Fews Lane, Longstanton

Drainage Review

On behalf of **Greater Cambridge Shared Planning**

Report Title: Drainage Strategy Review

Figure 3 Drainage Layout Plan

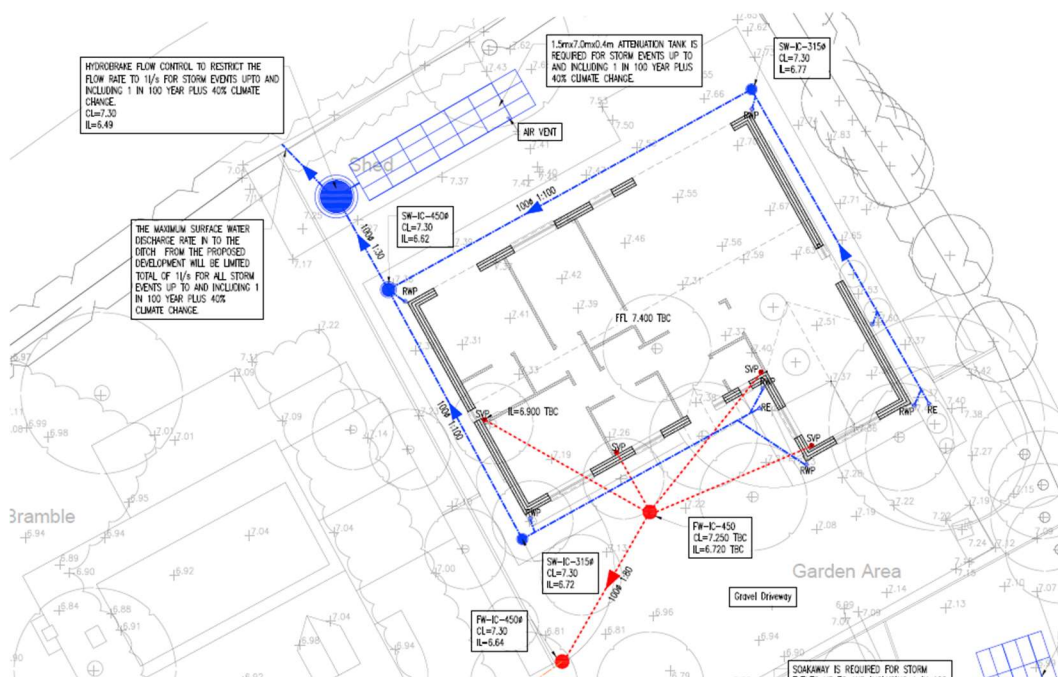
- 4.2.1 The Drainage Layout Plan Rev P9 shows the single dwelling is to discharge surface water to an attenuation tank located within the rear garden of the property.
- 4.2.2 The proposed tank is 1.5m x 7.0m x 0.4m and is stated in the Drainage Layout Plan Rev P9 as being capable of storing to up to the 1 in 100 year plus 40% climate change event. A hydrobrake flow control chamber is shown at the outfall to the proposed storage tank.
- 4.2.3 Supporting calculations supplied show the tank has been modelled to accommodate the storage required and the flow control is capable of limiting flow to the rate within the range of 1l/s. See Figure 3 below, which is a screen shot of the proposed drainage.

- 4.2.4 The drainage plan shows the proposed driveway is a proposed gravel driveway operating as an infiltration feature. Refer to **Appendix B**.
- 4.2.5 Infiltration tests show infiltration rates within this location is at a rate of 6.97E-06 and therefore in accordance with **The SuDS Manual** is considered a suitable rate for use of infiltration. The geotechnical report also submitted in support of this design shows the land immediately to the west to be underlined with Clay Soil, the soil is classed as having a high to very high plasticity content. **Refer to Appendix C**.

- 4.2.6 The Drainage Layout Plan Rev 9 shows the proposed two new units, the southern site, and part of a separate planning application, are to use individual house soakaways within the rear gardens and porous paving in the driveway to discharge surface water runoff. The infiltration rates applicable to these two properties are a higher rate than the site.

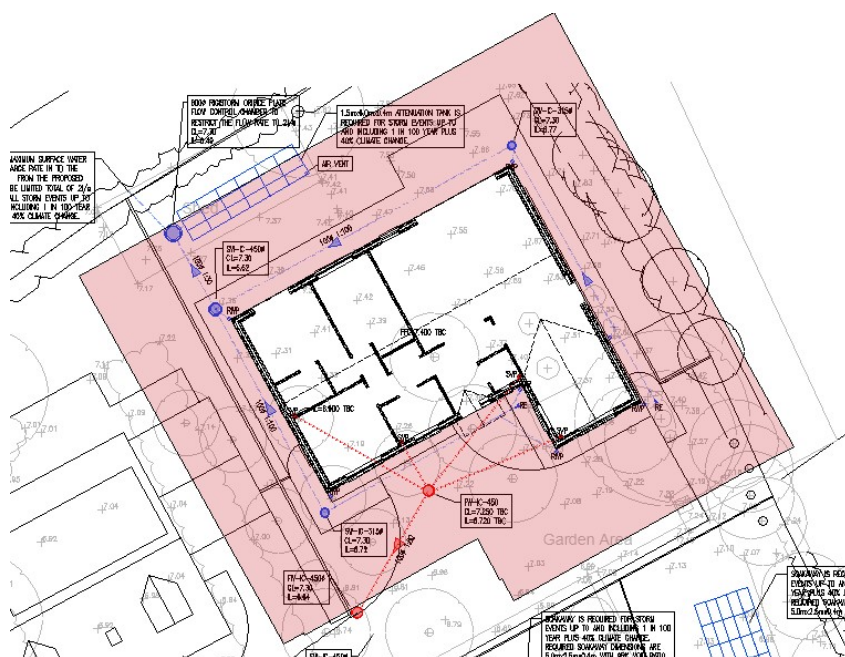
- 4.3.17 A 5m offset if applied to the footprint would therefore leave an area of approximately 2.5m distance from the bank of the existing watercourse. See Figure 4.
- 4.3.18 Locating soakaways adjacent to the watercourse is considered to result in a limited unsaturated zone, this would therefore do little to reduce rates into the watercourse, provide little water quality treatment and would therefore be contrary to **The Cambridgeshire SPD** and design best practice.

4.3.19 It is noted there is space available along the frontage of the proposed property, outside of the 5m offset, as illustrated in Figure 4. However, locating a soakaway feature in this area would place it directly adjacent to the proposed two residential plots within the southern site, resulting in two soakaway features being within 3.5m of each other. This would further increase the potential risk from expansion of the soils. Levels within this area of the site are also higher than those within the rear of the property, requiring a deeper soakaway feature, making maintenance more of a challenge.

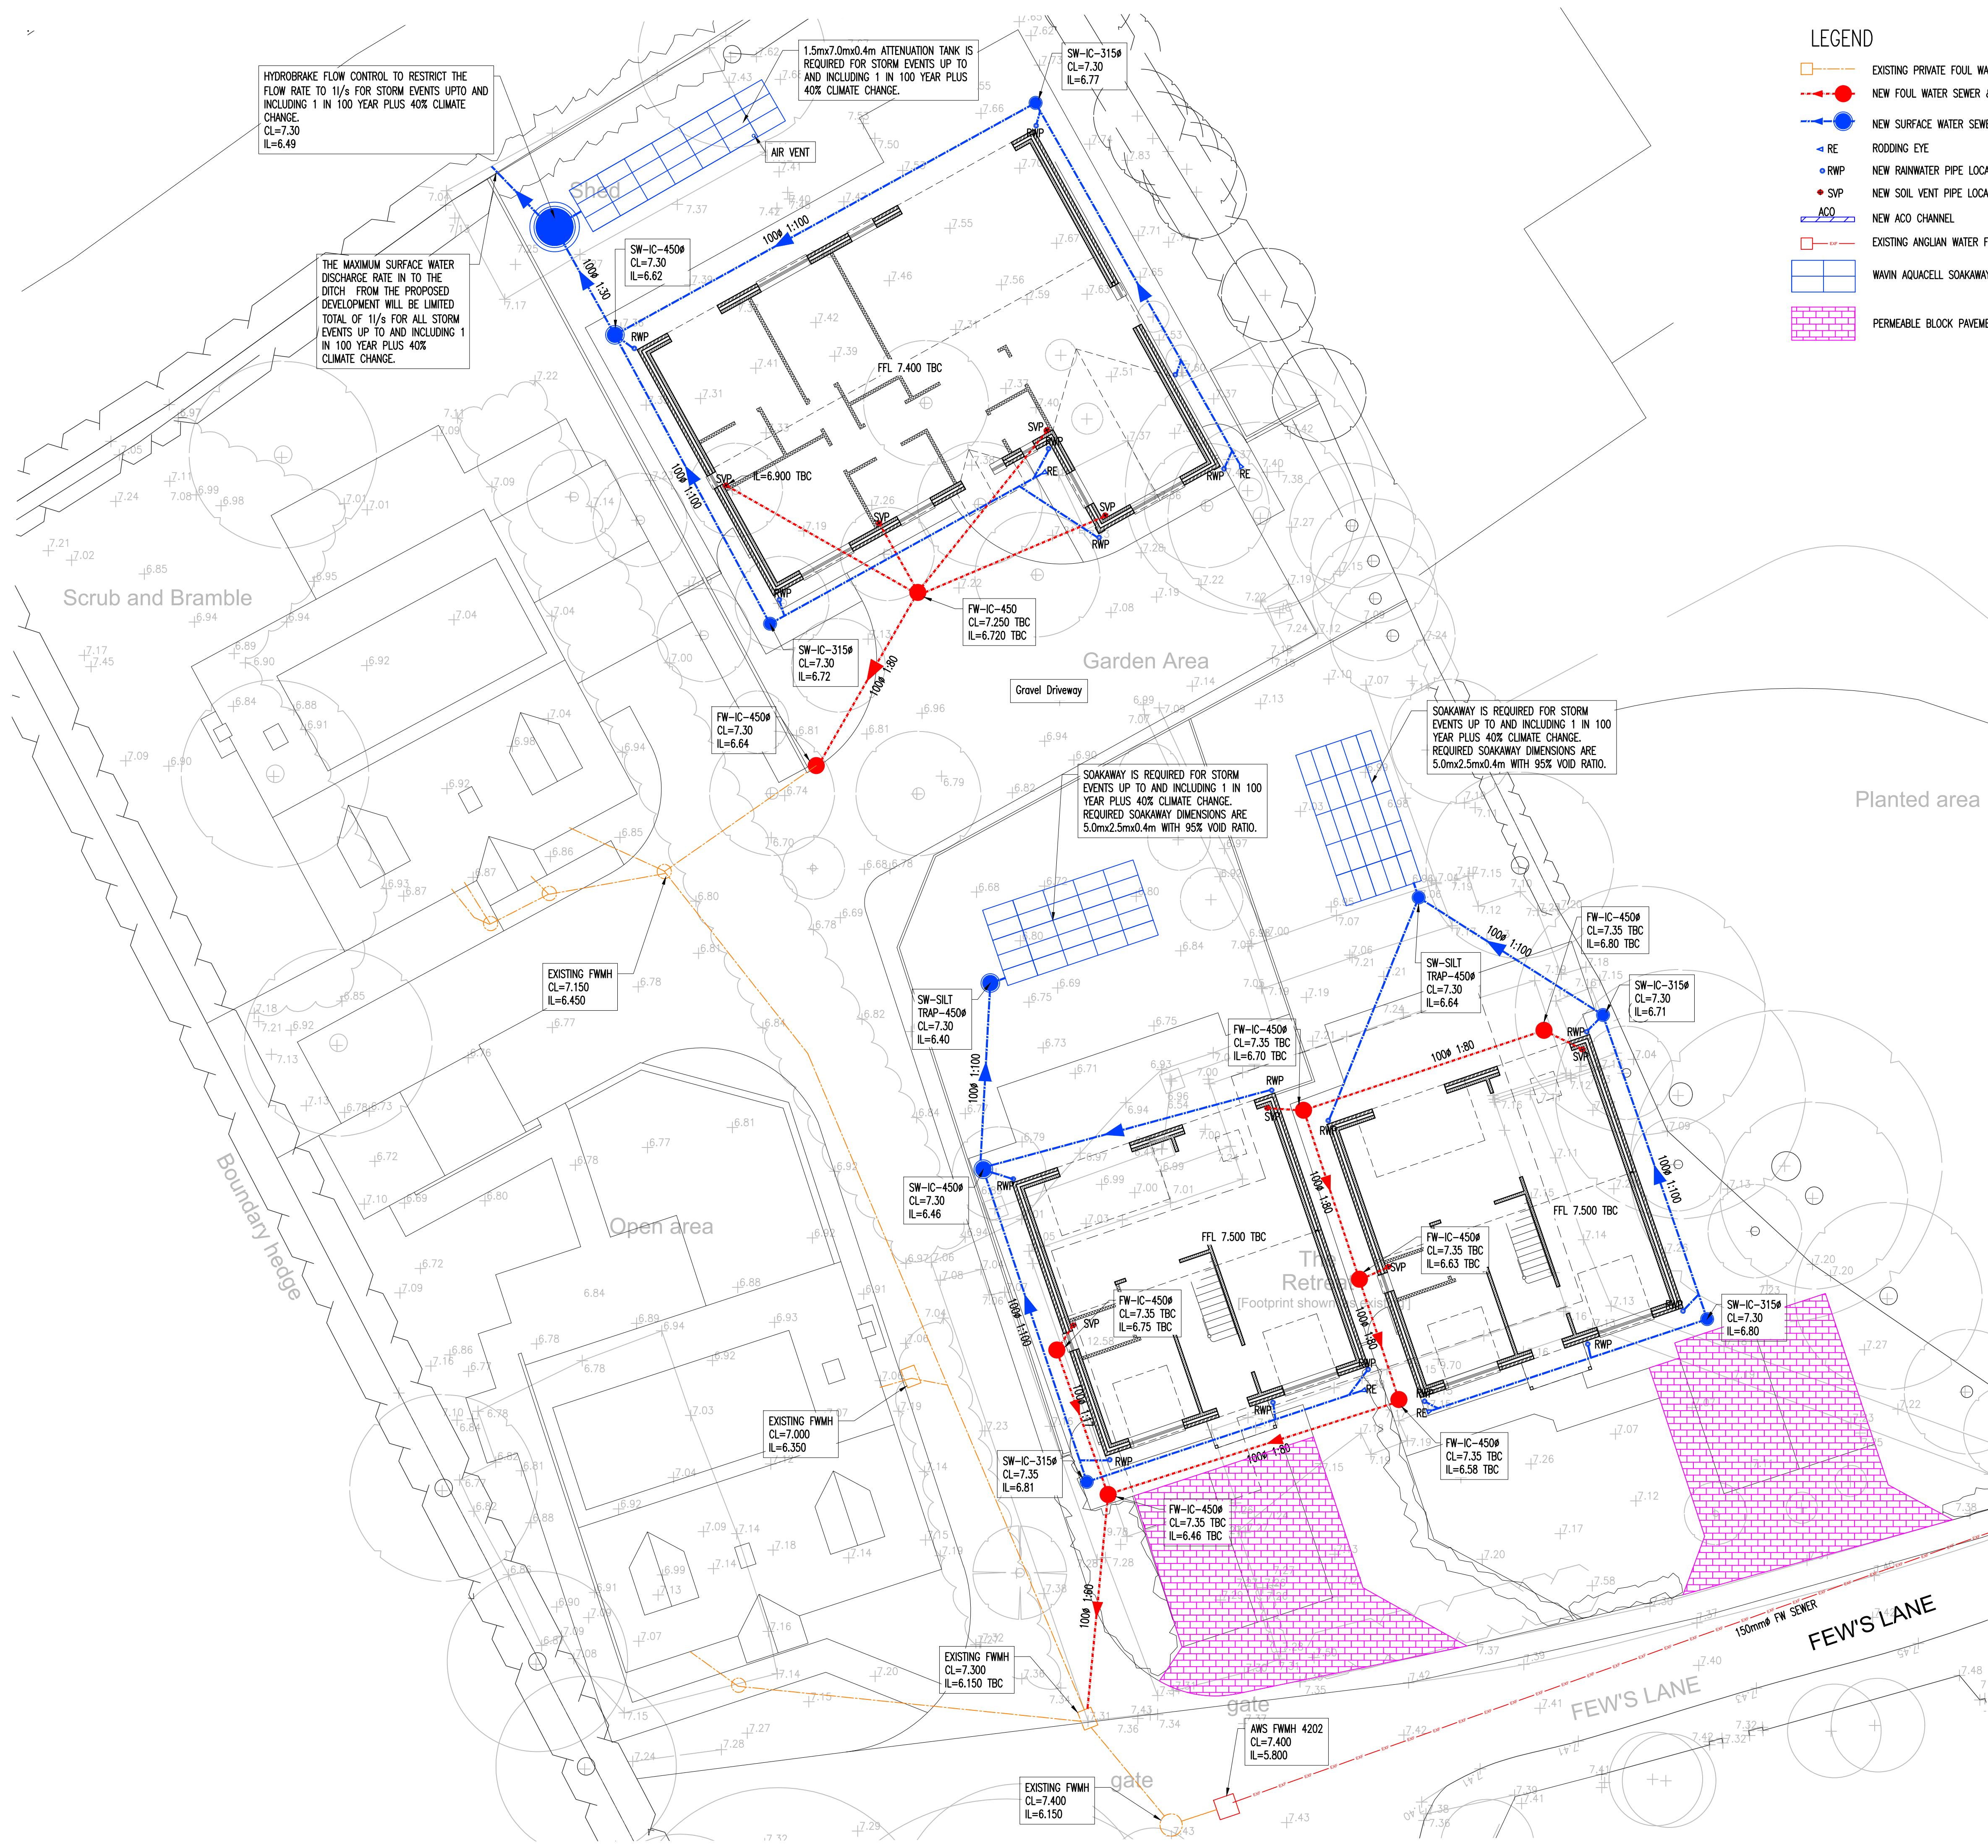
- 4.1.1 The proposal is illustrated on Drainage Layout Plan Ref 19/0321/100 Rev P9 (hereafter referenced as Drainage Layout Plan Rev P9) and shows the proposed dwelling will discharge foul drainage to an existing foul sewer in Few's Lane.

DITCH PLAN
(SCALE 1:100)

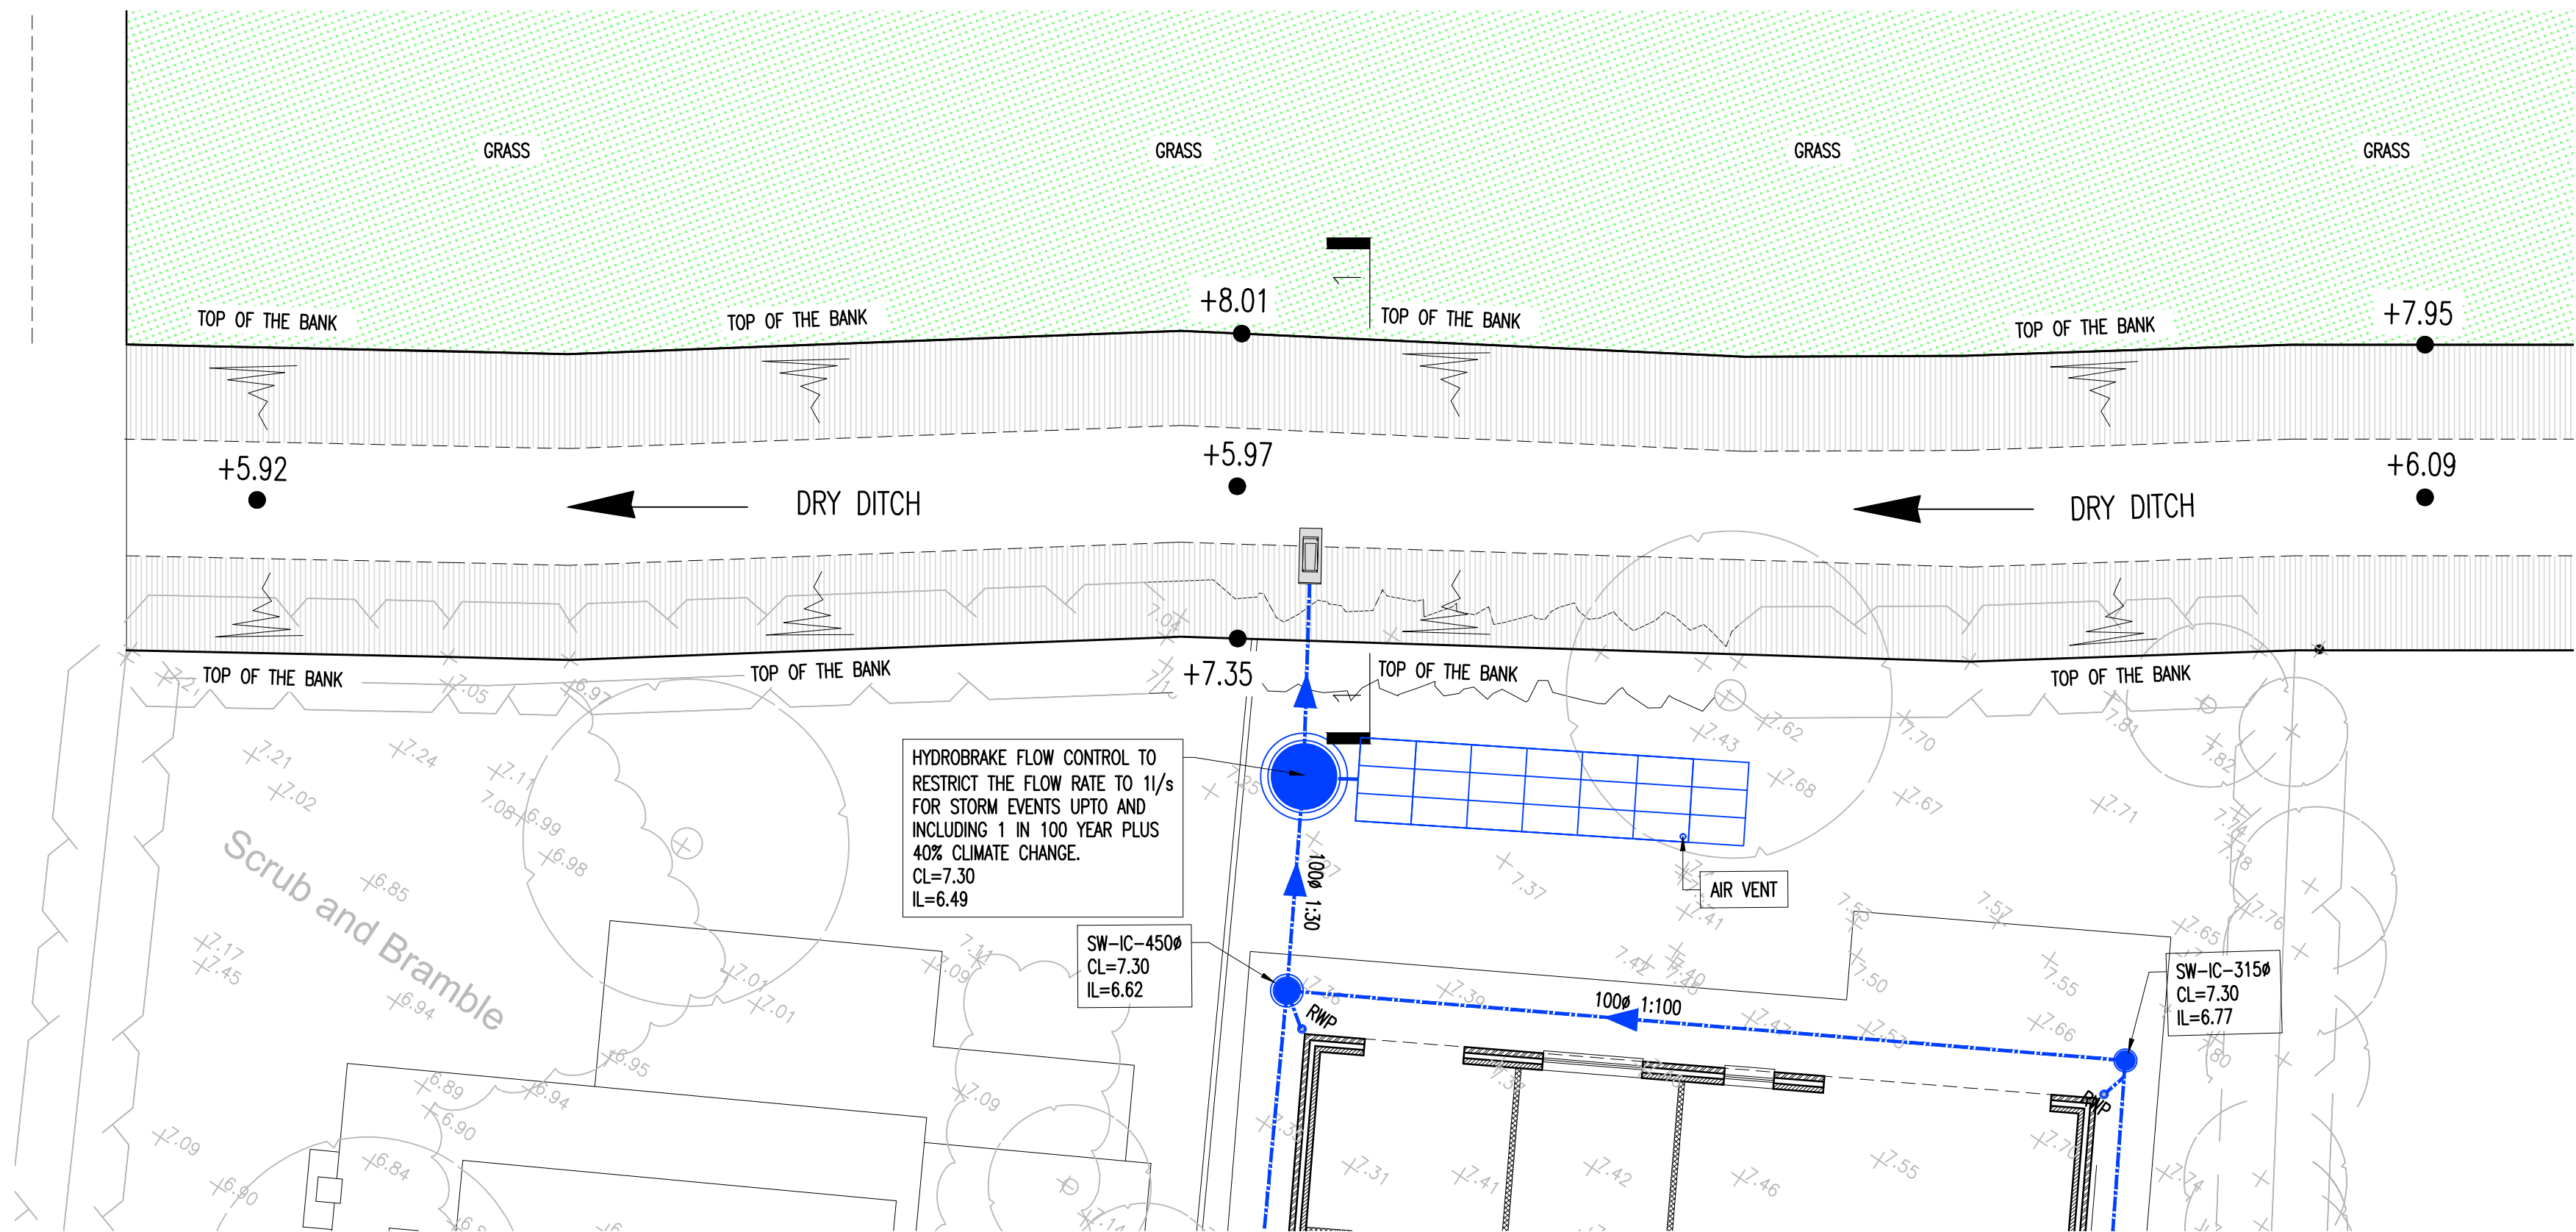
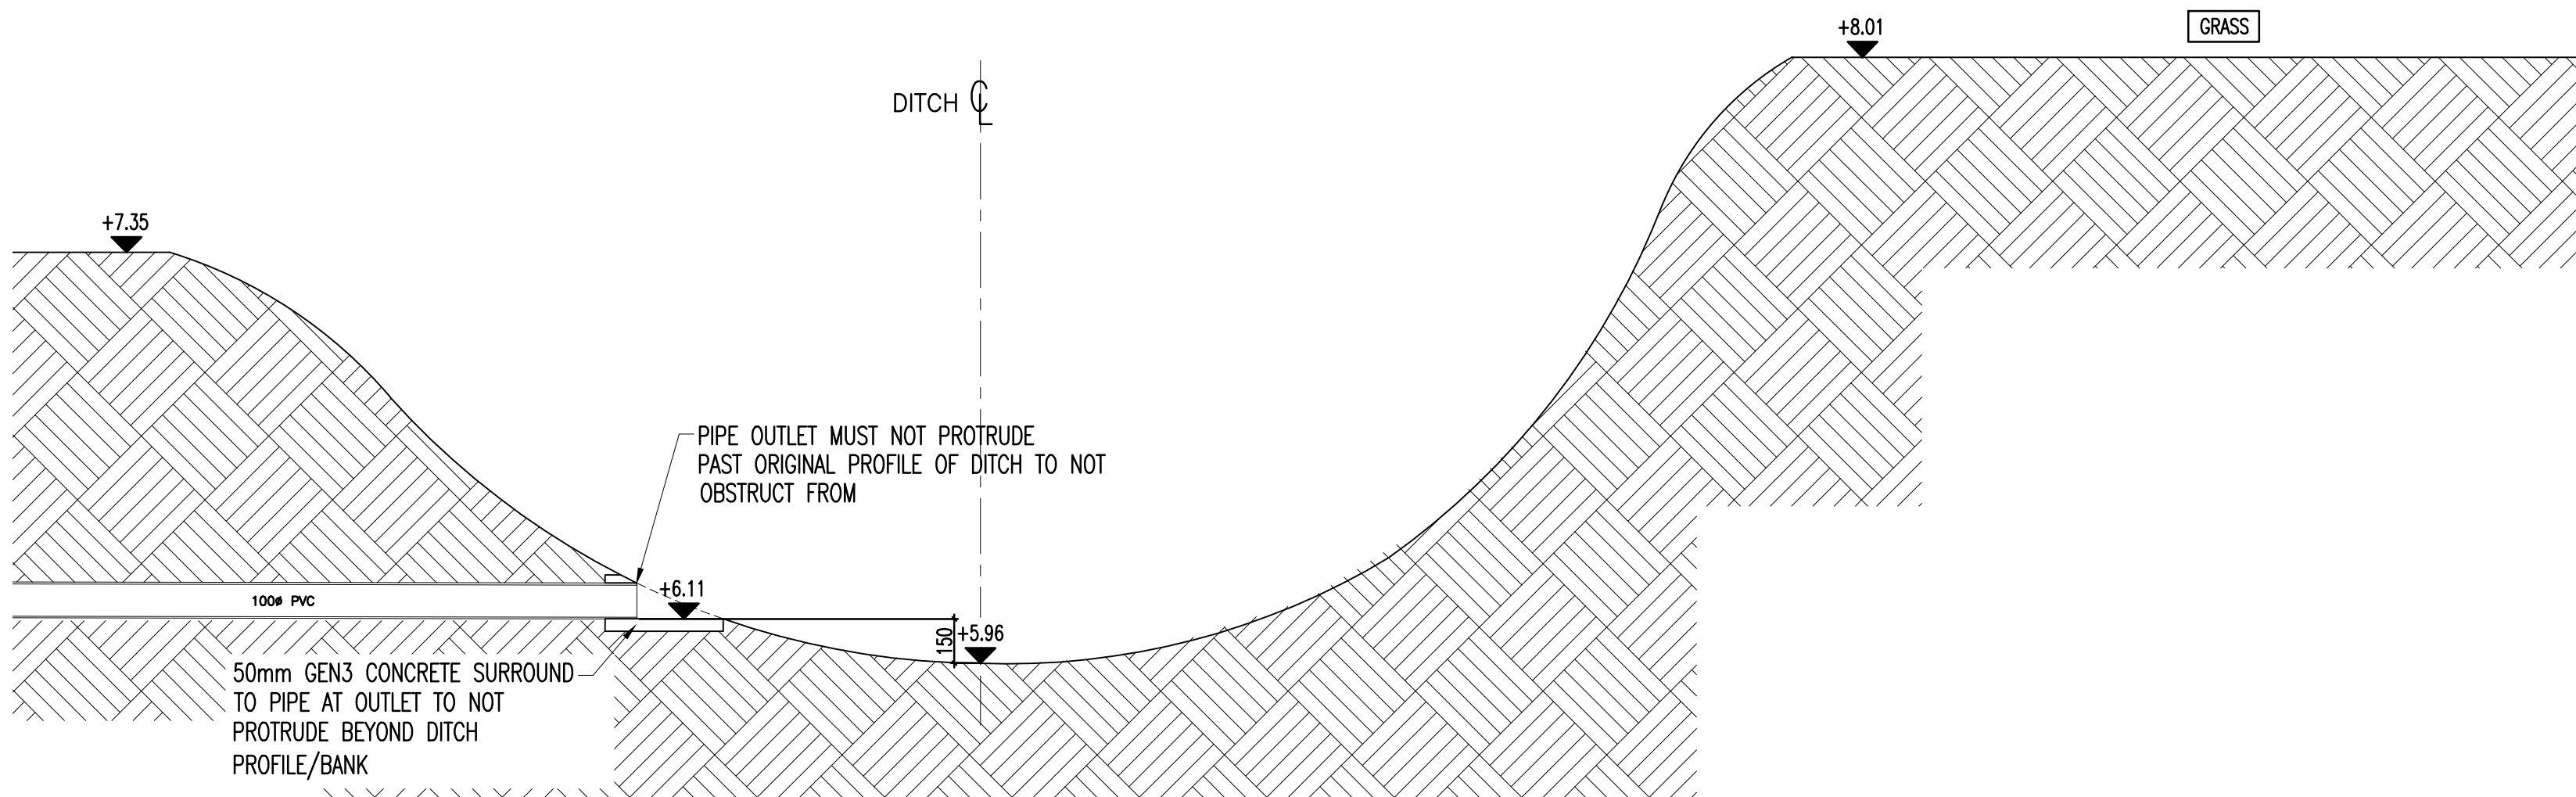
- 2.2.7 Cross sectional information has been issued associated with the proposed outfall arrangement for the surface water drainage into the existing watercourse (drawing 19/0321/1010 Rev P3). The cross section shows the watercourse to be at an approximate depth of 1.39m, on the bank side of the site, and 2.05m depth on the far north bank to the site. The width of the ditch has been measured as approximately 5.3m wide, at the top of bank, and 2m wide at the base of the watercourse. Refer to drawing 19/0321/1010 P3 in **Appendix B**.

site. The existing watercourse dimensions are illustrated on the supporting ditch profile drawing Ditch Plan and Section drawing reference 19/0321/101 Rev P3 (**Appendix B**) and using this information we can confirm the following:
